Change Order No. Nine (Construction Change) to C.F. Jordan L.P. for "EPIA Consolidated Security Checkpoint & Terminal Apron project" for an increase amount of \$ 67,903.91 An increase in the Contract amount due to.

CITY OF EL PASO PURCHASING CHANGE ORDER

DATE: 05/12/04
PROJECT: EPIA Consolidated Security Checkpoint & Terminal Apron
TO (Contractor): C. F. Jordan LP

CHANGE ORDER NO.: 09
☐ SCOPE CHANGE ☒ CONSTRUCTION CHANGE
BID NO.: 2003-129
DEPT. ID#: 62620031
PROJ/GRANT/USER: G620AIP0019
FUND: 11508
ACCOUNT: 508027
PO NO.: 2003008049

Copies:	Description:
1	Proposal Request #8

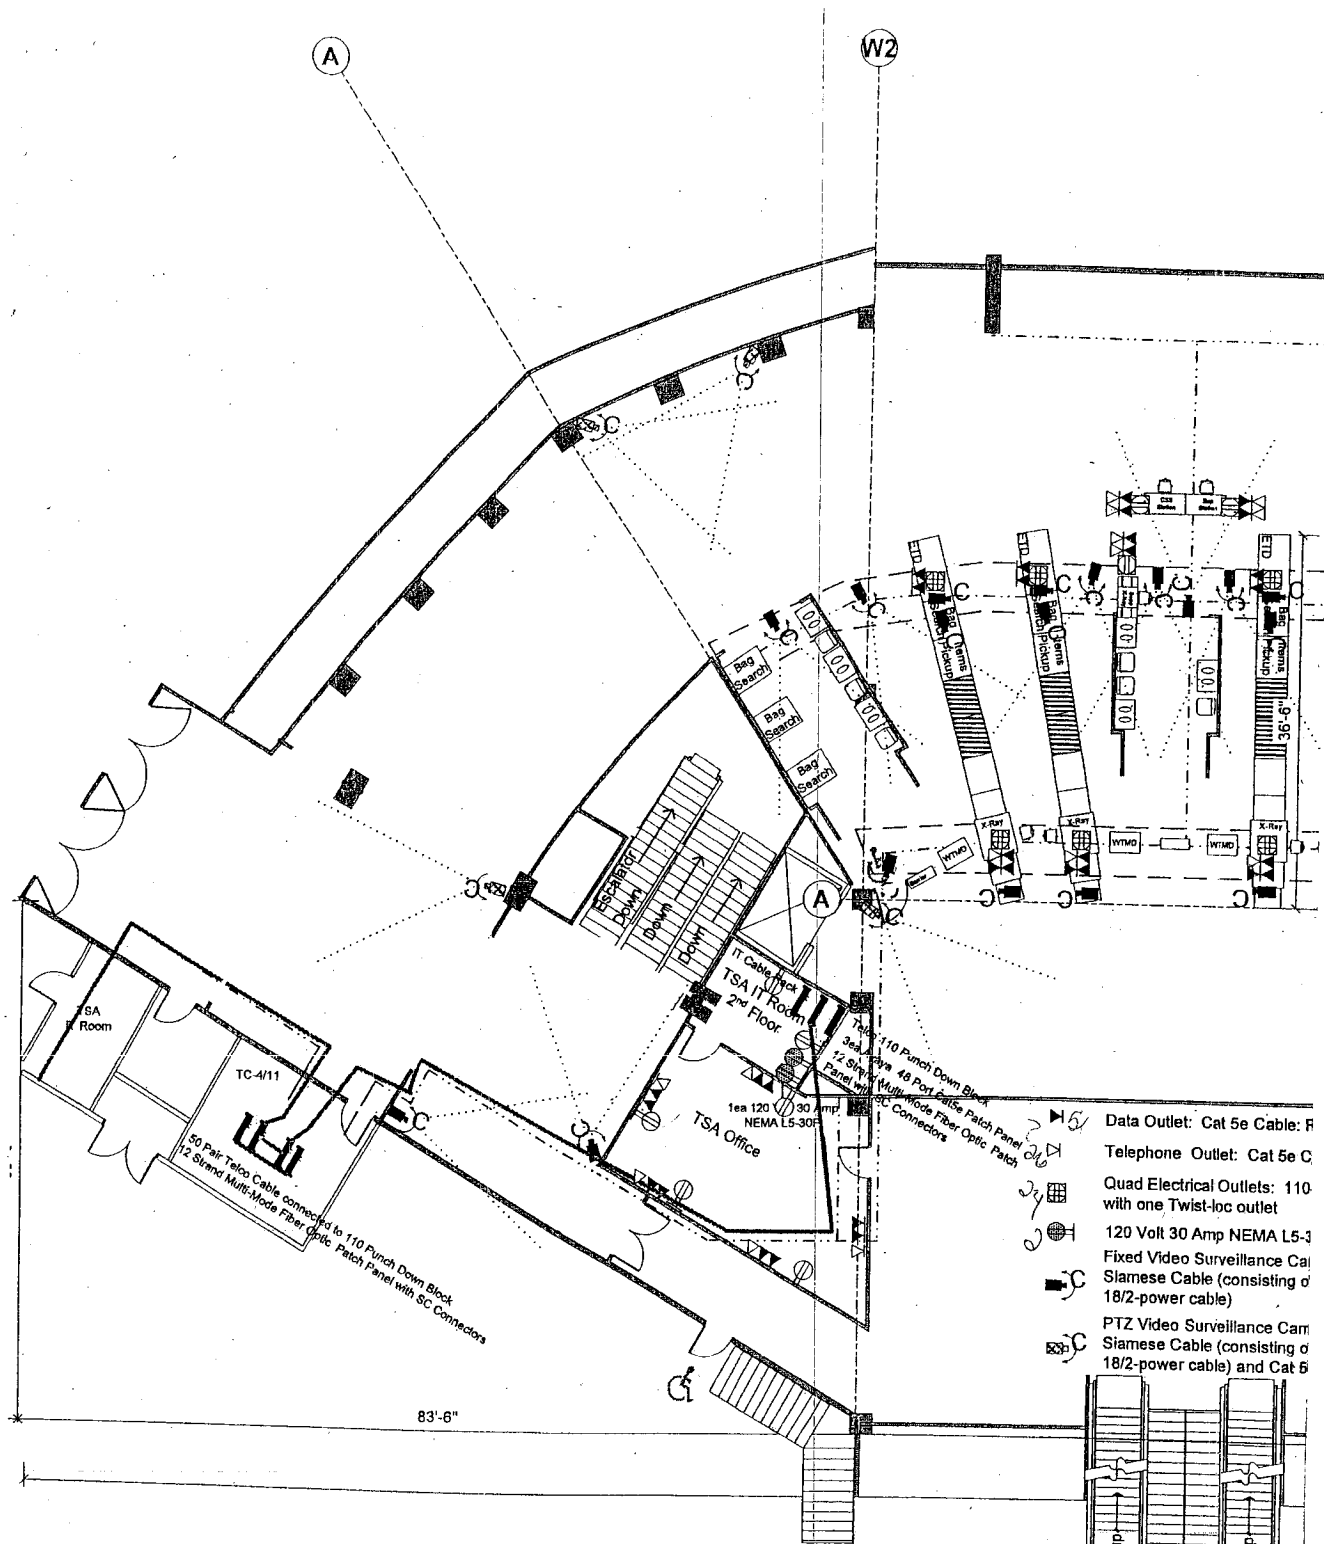
1. Provide cabling and connection of additional cameras, data and telephone outlets as shown on the attached layout from the Transportation Security Administration (See Attachment PR8.1).
2. Provide additional electrical connections as shown on the attached layout from the Transportation Security Administration (See Attachment PR8.1).

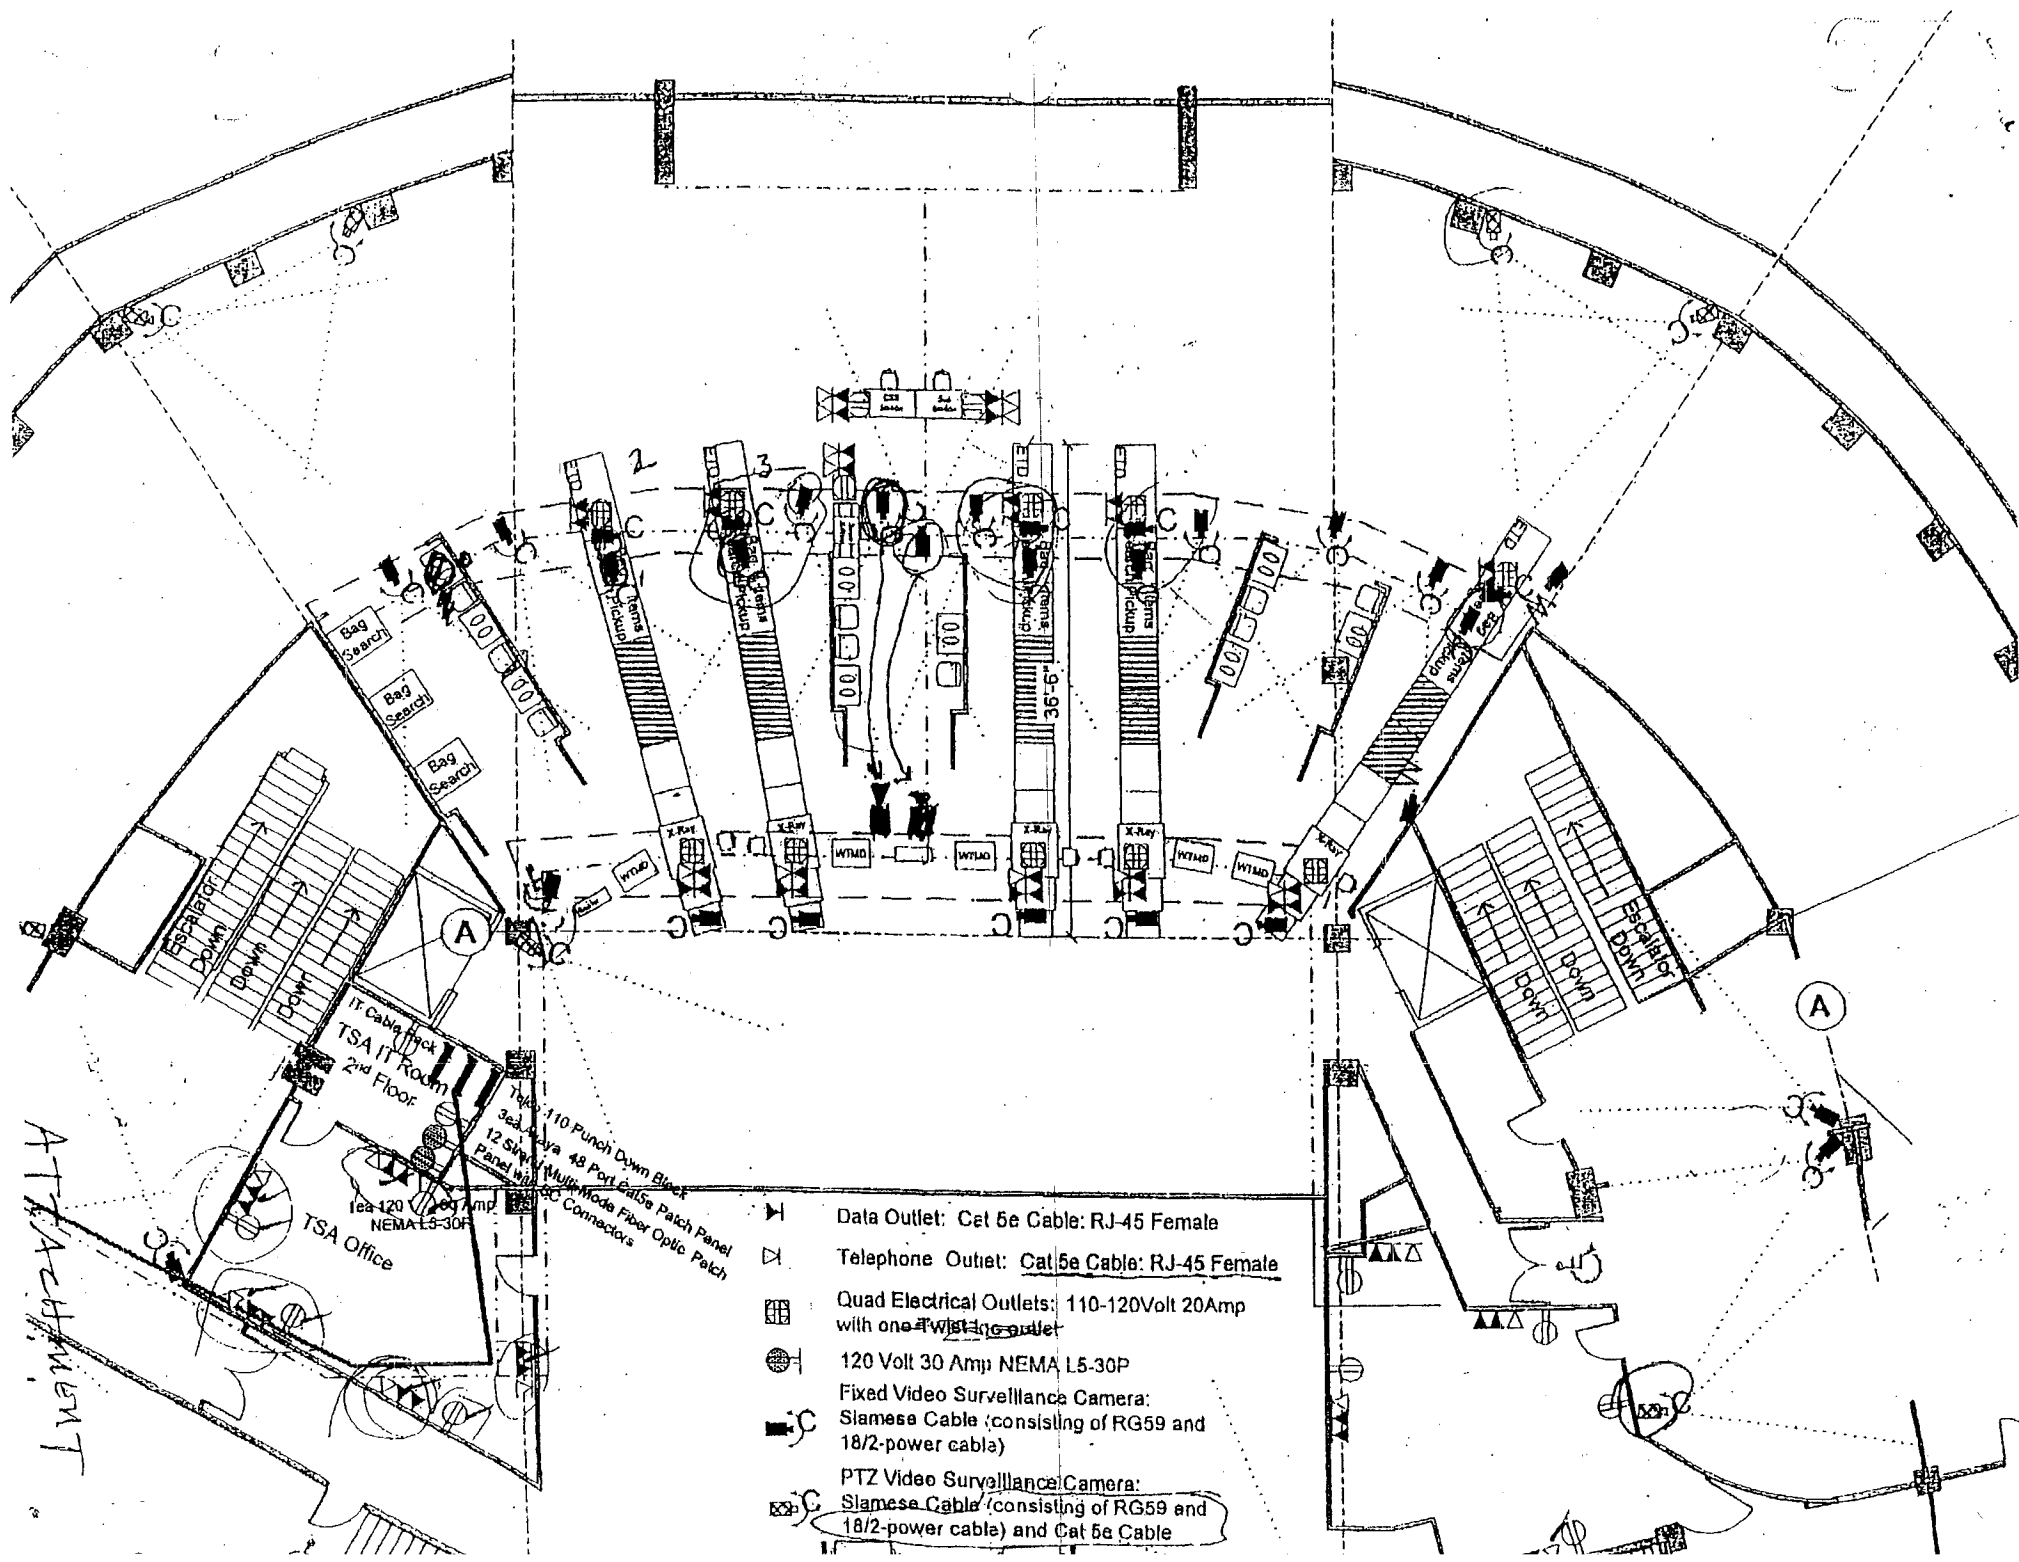
Install glass wall panels @ Security Screening Area. Wall panels are to be provided by TSA. Contractor is to confirm layout and installation requirements with TSA prior to Installation. See Attachment PR14.1 for wall panel layout.

PARTIAL REVISED HVAC 2ND FLOOR PLAN

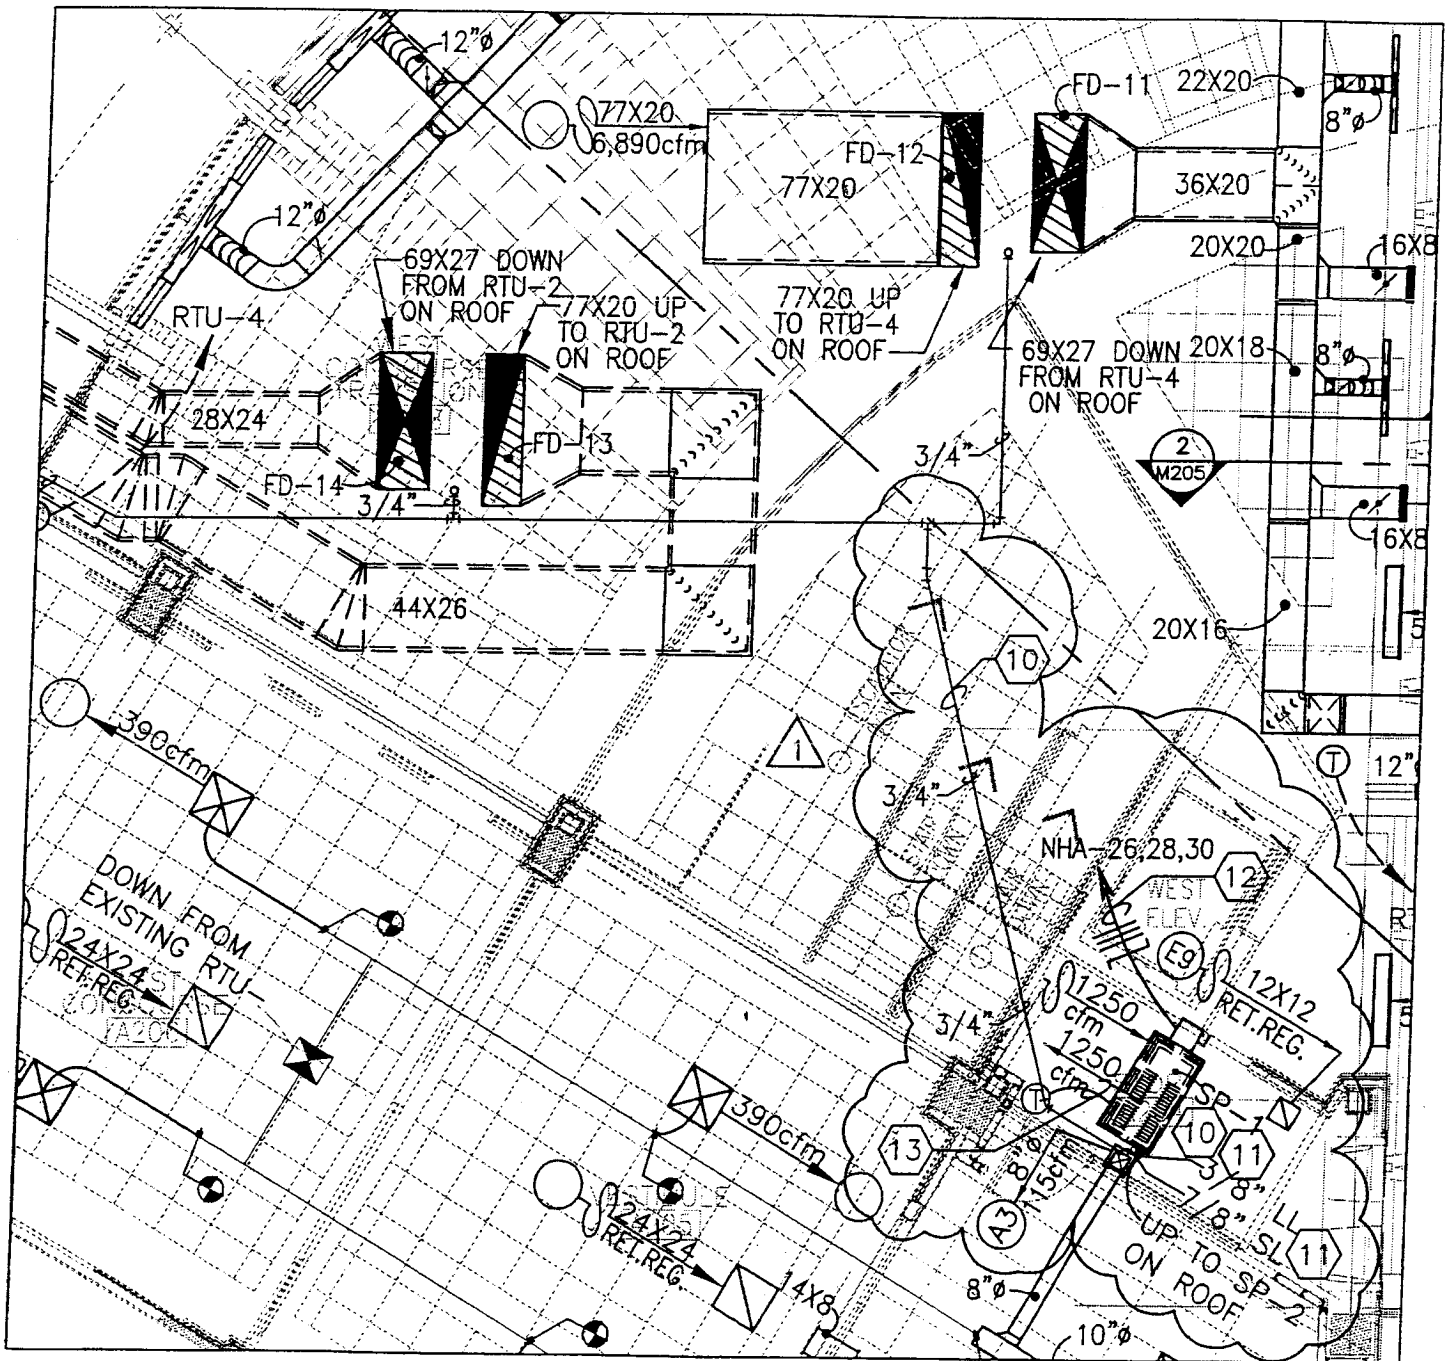
Provide and Install additional HVAC unit for Room A204 as indicated on Attachments PR.12.1 through PR.12.5

- 1 CONTRACTOR TO VERIFY EXACT SIZE OF DUCTWORK.
- 2 SEE DRAWING M202 FOR DUCTWORK CONTINUATION.
- 3 INSTALL WIRE MESH RETURN GRILLE
- 4 NEW CONDENSATE LINE FROM UNIT ON ROOF. COORDINATE ROUTING AS NECESSARY TO AVOID CONFLICTS

- 5 ADDED CEILING DIFFUSER WITH CFM REQUIREMENT NOTED. APPROXIMATE ROUTING AND POINT OF CONNECTION SHOWN AS WELL AS DUCT SIZE REQUIRED. (TYPICAL)
- 6 REPLACE EXISTING DIFFUSER WITH MATCHING DIFFUSER FOR NEW WORK. PROVIDE SIZE AS REQUIRED.

- 7 PROVIDE FIRE/SMOKE DAMPERS AS REQUIRED BY DUCT SIZE.
- 8 ALL SINGLE SLOT DIFFUSERS SHALL HAVE HORIZONTAL THROW TOWARDS THE EAST AND WEST CONCOURSE TRANSITION ACCORDINGLY. (TYPICAL)

- 9 ALL DOUBLE SLOT DIFFUSERS SHALL HAVE VERTICAL AND HORIZONTAL THROW. (TYPICAL)
- 10 PROVIDE A CONDENSATE PUMP IF CONDENSATE DRAIN FROM UNIT IS BELOW THE TIE-IN POINT. CONTRACTOR SHALL FIELD VERIFY EXACT LOCATION AND MAKE NECESSARY ADJUSTMENTS.

- 11 PROVIDE INSULATION FOR LIQUID LINE AND SUCTION LINE. INSULATION SHALL BE POLYELEFIN WITH WEATHERPROOF JACKET.
- 12 EXTEND 3#10, 1#10 GND. IN 3/4"C. TO CIRCUIT INDICATED. FURNISH AND INSTALL A 15A/3P HACR BREAKER IN SPACES 26,28,30 OF PANEL "NHA" TO FEED THIS EVAPORATOR.

PARTIAL REVISED HVAC ROOF PLAN

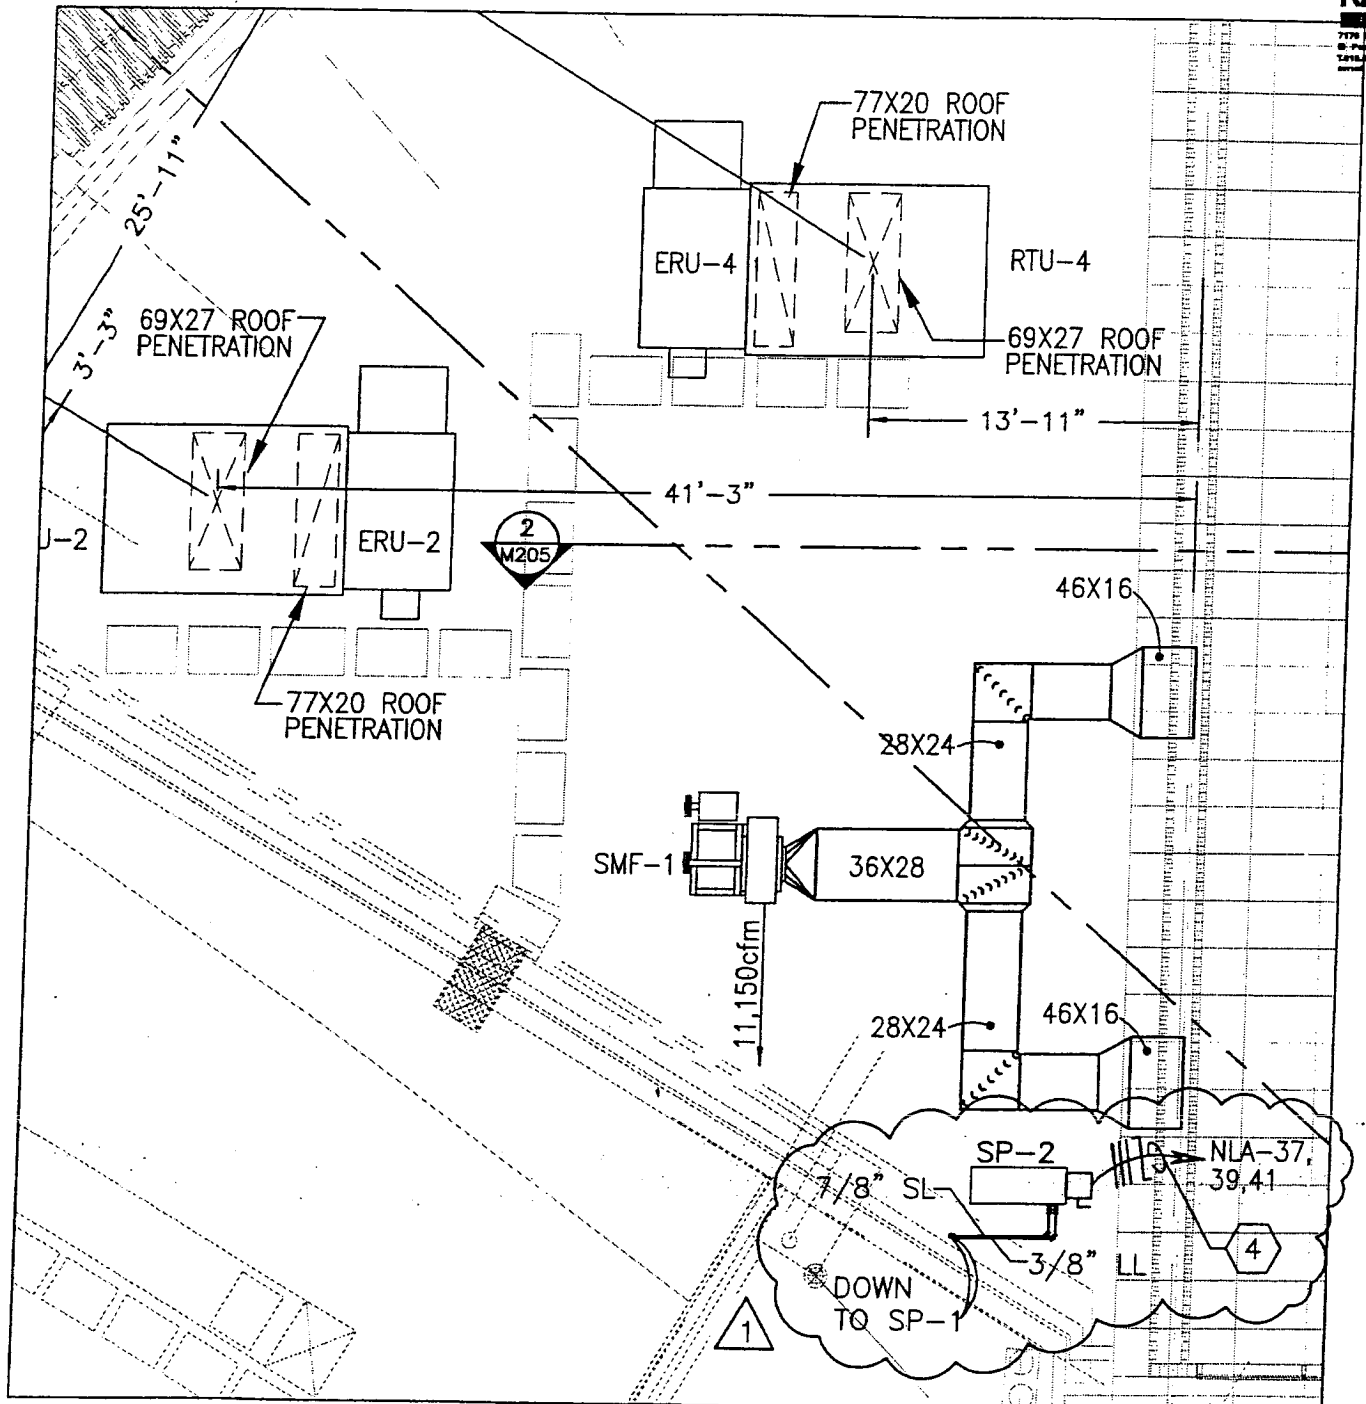
3 PROVIDE INSULATION FOR LIQUID LINE AND SUCTION LINE. INSULATION SHALL BE POLYETHYLENE WITH WEATHERPROOF JACKET.

4 EXTEND 3#10, 1#10 GND. IN 3/4" C. REMOVE EXISTING 20A/1P BREAKER FROM CIRCUITS 37,39,41 AND REPLACE WITH A 25A/3P HACR BREAKER TO FEED THIS CONDENSER.
